# 1970 Corvette: Service Bulletin: Water Pump Bearing and/or Shaft Failures

**Source:** Chevrolet Dealer Service Technical Bulletin

**Bulletin No:** 71-T-37

**Date:** June 23, 1971

FIGURE-1

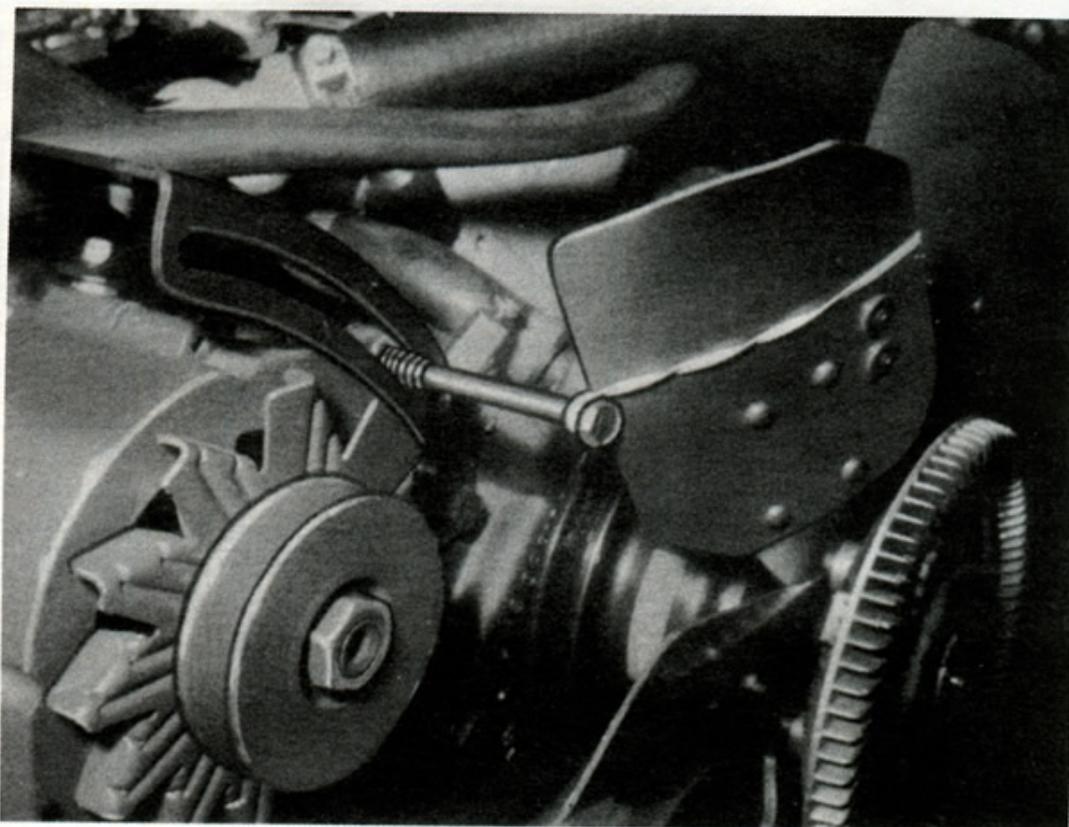
- A. Secure the fan blade to prevent rotation. (See Figure 1).
- B. Mount a dial indicator (.001 graduations) to the engine and place the indicator pointer on the fan blade spider. Preferably on the longest

FIGURE-2

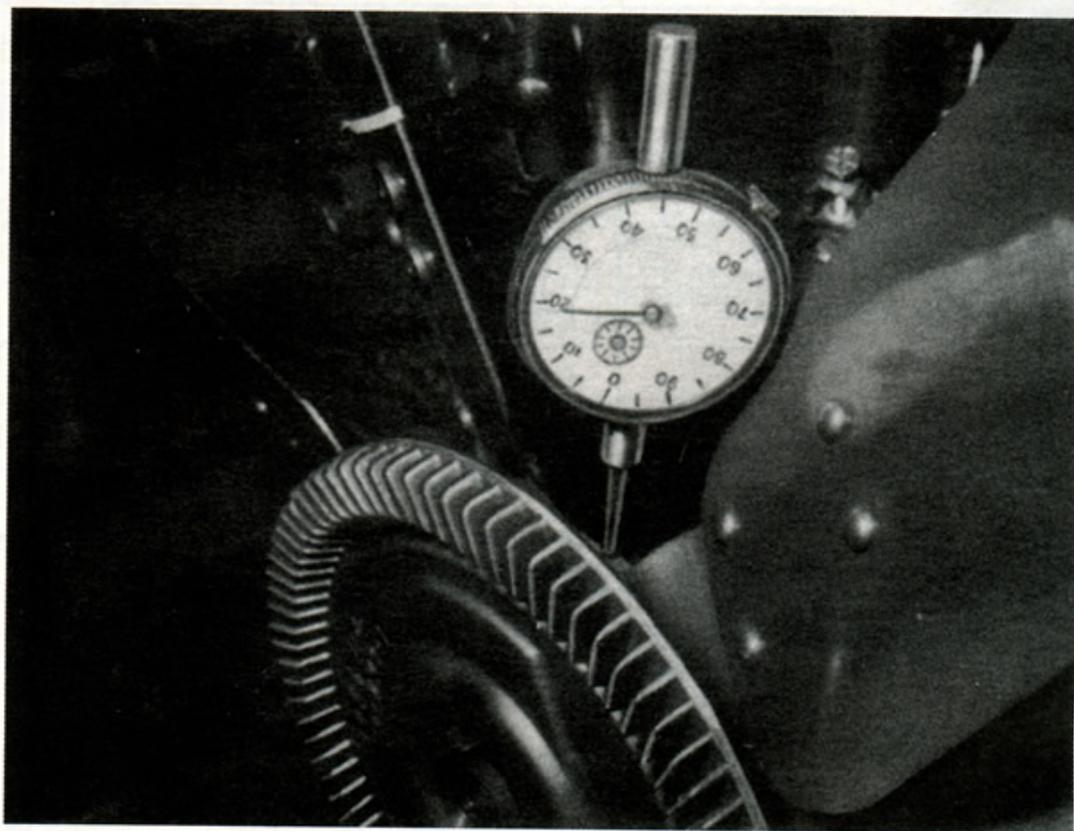
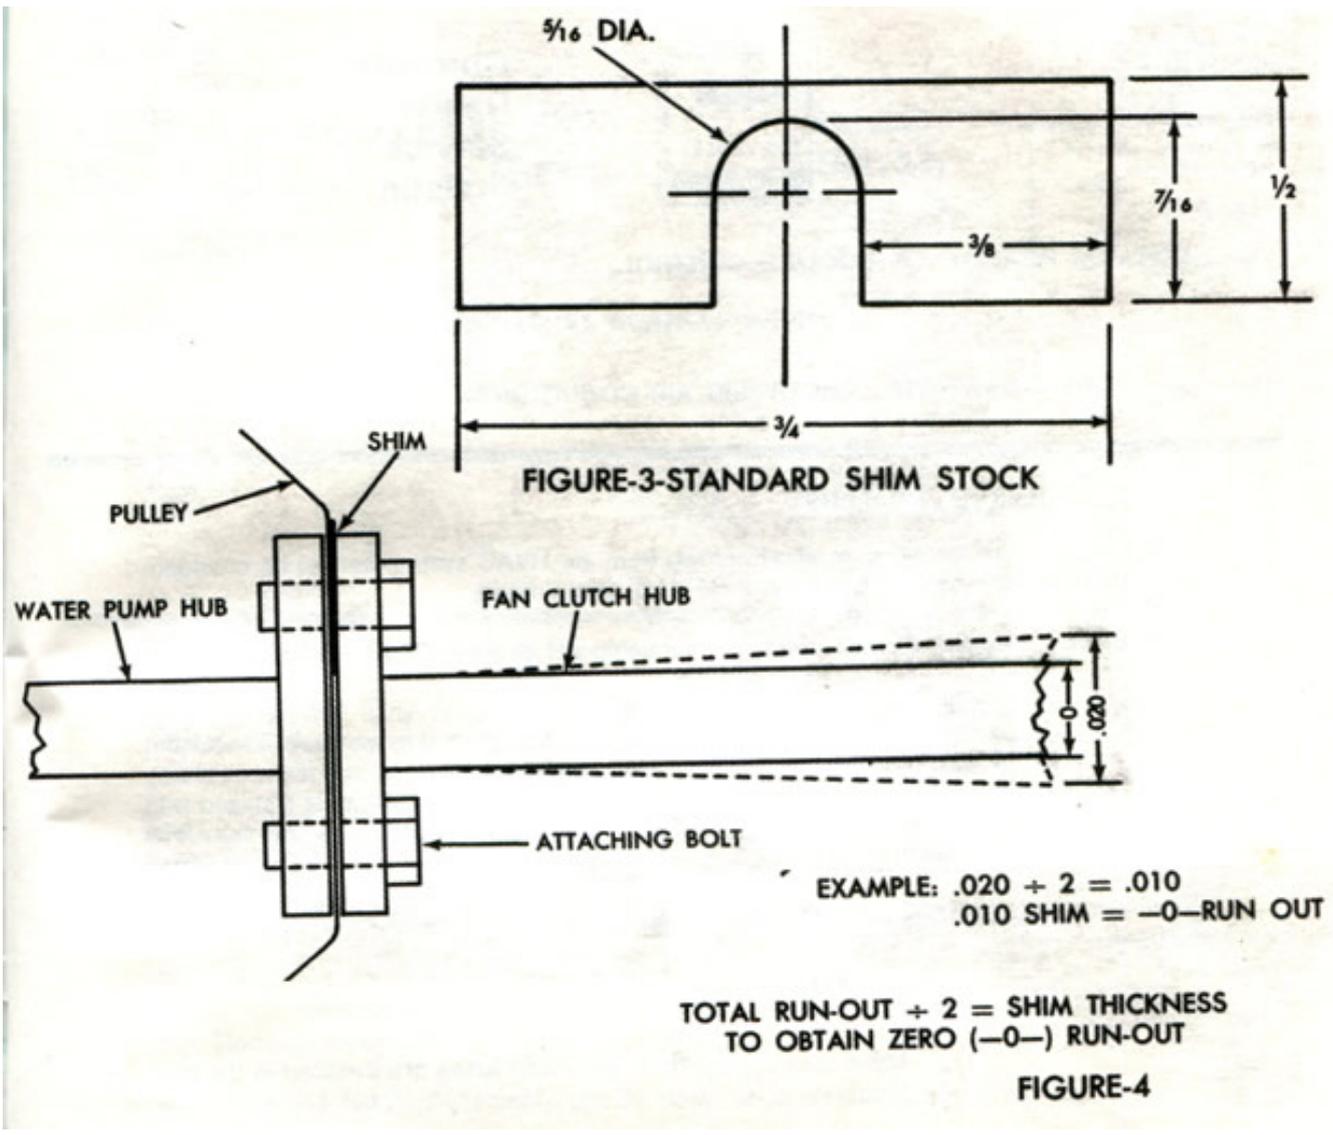
- band or space on the spider. (See Figure 2).
- C. Rotate the water pump pulley in one direction and note the total amount of indicator needle movement. This represents the total radial run-out. Mark the point on the pulley at which the highest reading is obtained.
